CITY OF ALBUQUERQUE

September 18, 2025

**RE: Sunport Apartments Ph II
2920 Mulberry St. SE
Conceptual Grading & Drainage Plan
Engineer's Stamp Date: 09/02/2025
Hydrology File: M15D036
Case # HYDR-2025-00319**

SUNPORT APARTMENTS PH II ALBUQUERQUE, NM	DRAWN BY BL
	DRAINAGE PLAN	DATE 09-02-25
09/02/2025 RONALD R. BOHANNAN P.E. #7868	5571 MIDWAY PARK PL NE ALBUQUERQUE, NEW MEXICO 87109 (505) 858-3100 www.tierrawestllc.com	SHEET # 1
PRELIMINARY - NOT FOR CONSTRUCTION		JOB # 2022096

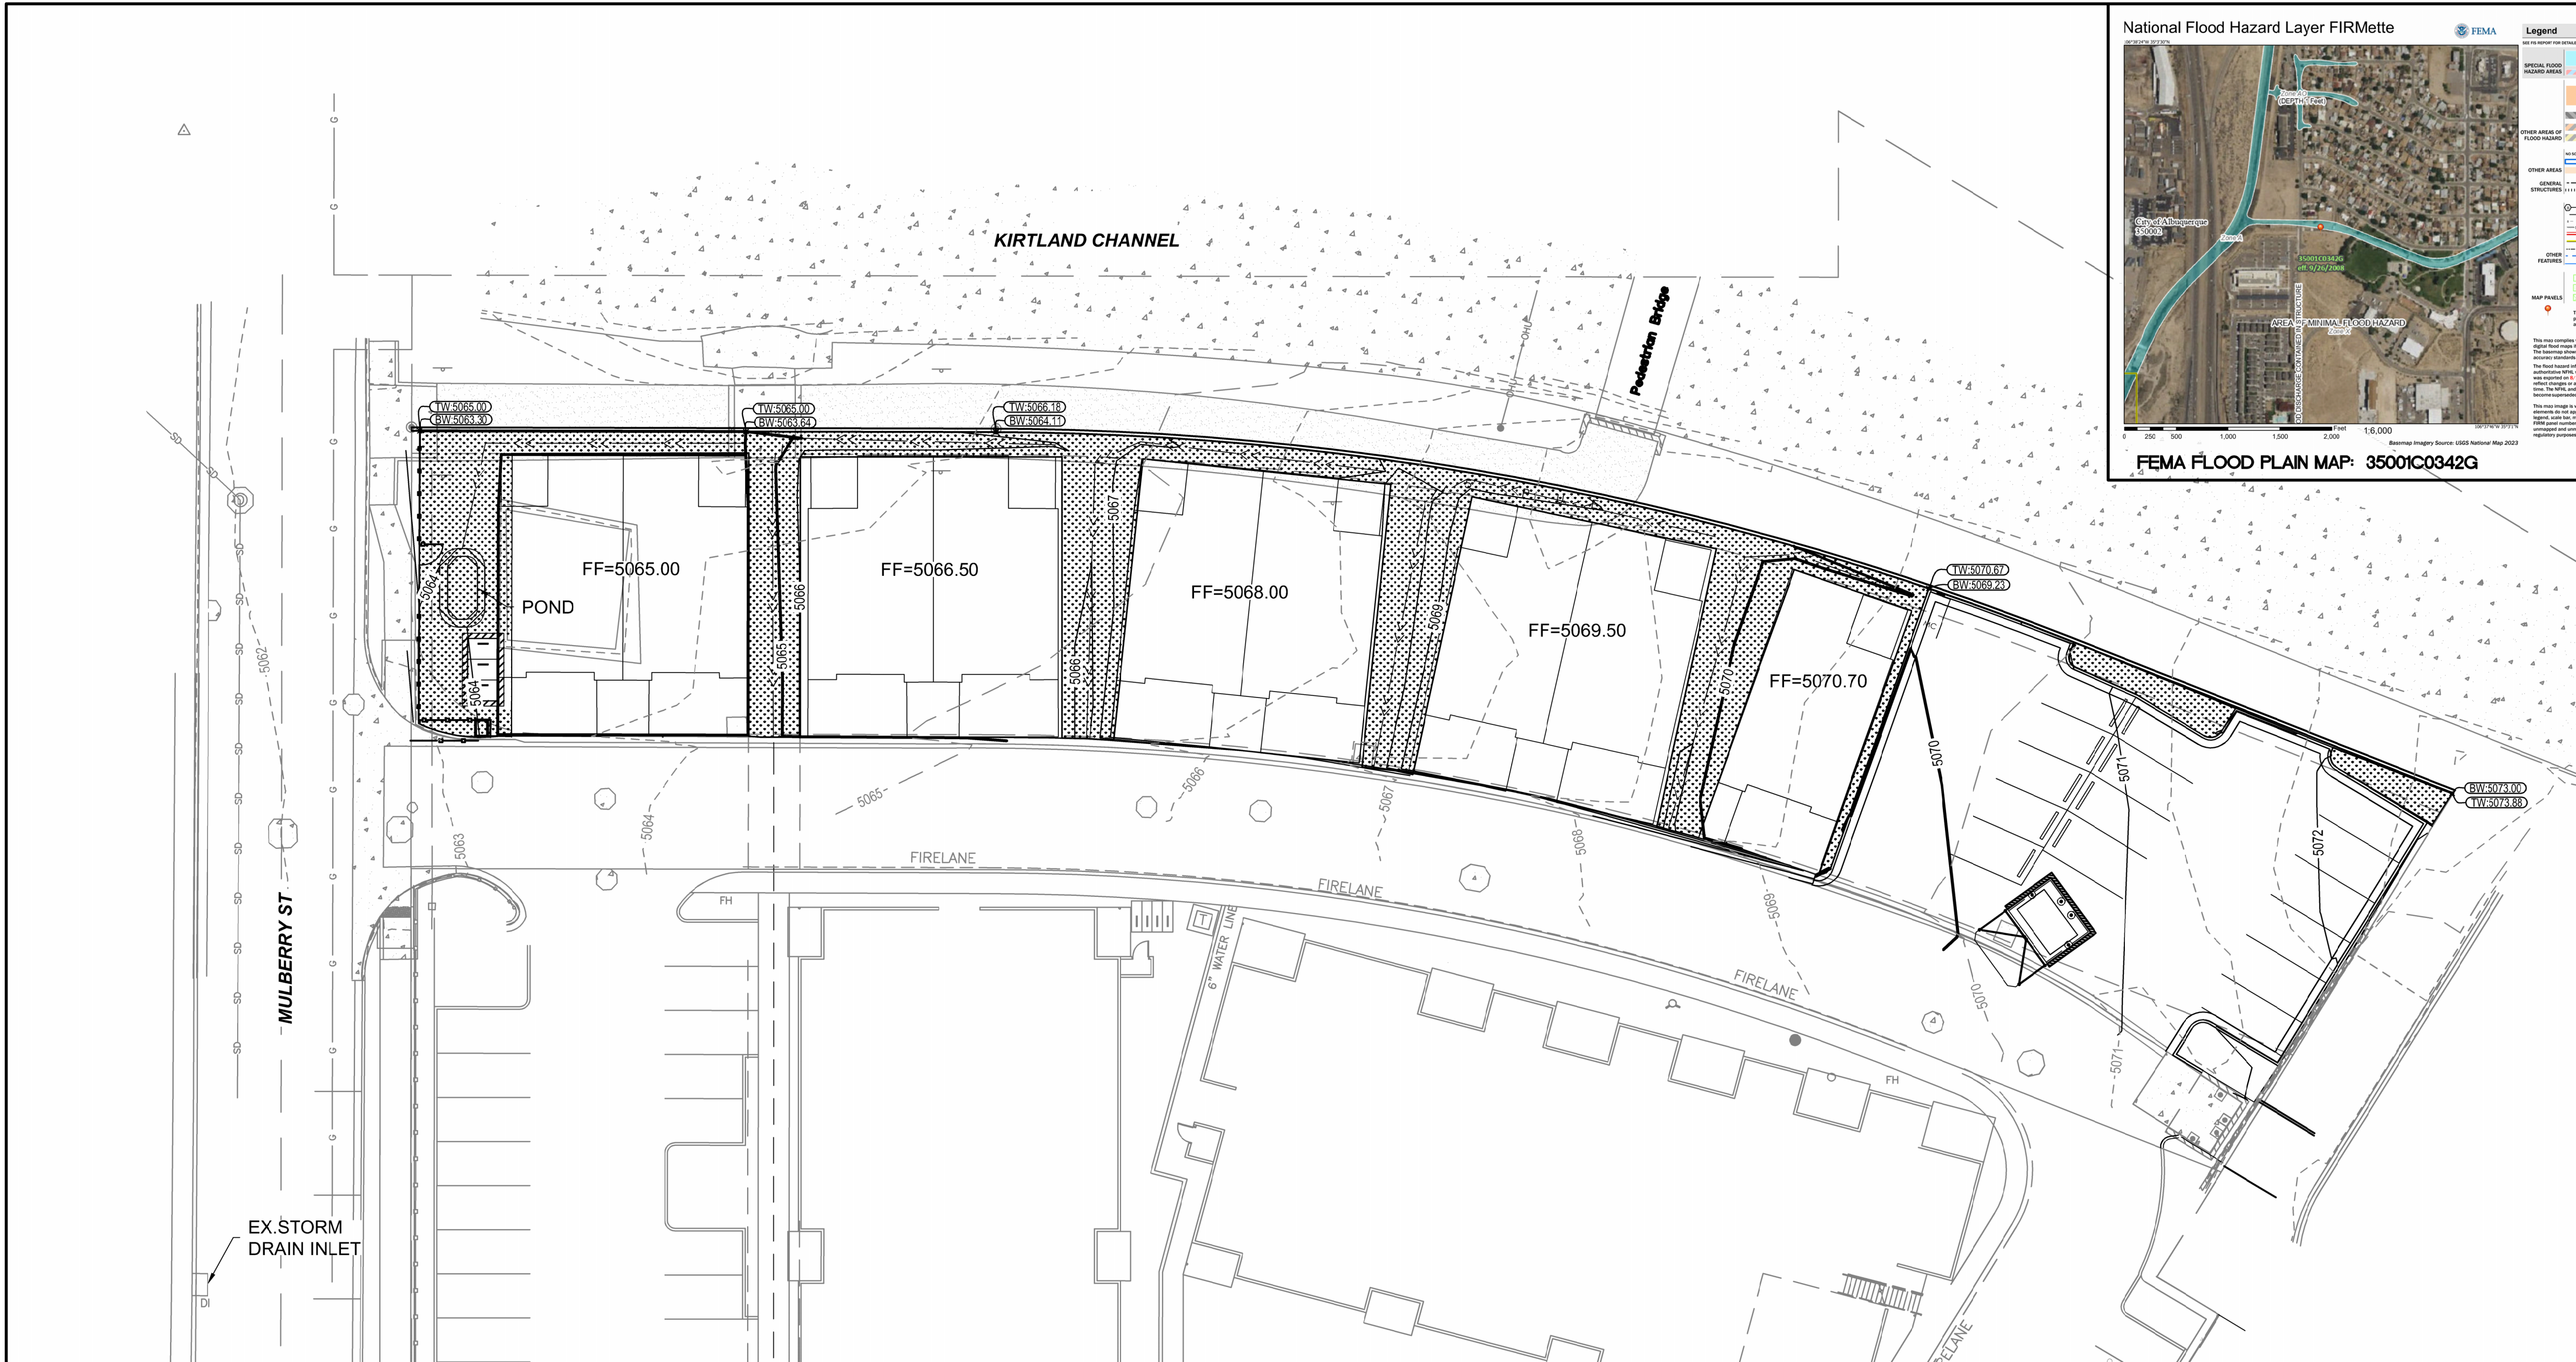
Based upon the information provided in your submittal received 09/03/2025, the Conceptual Grading & Drainage Plan is preliminary approved for action by the Development Facilitation Team (DFT) / Development Hearing Officer (DHO) on Site Plan for Building Permit and platting action.

1. Please submit a more detailed Grading & Drainage Plan to Hydrology for review and approval.
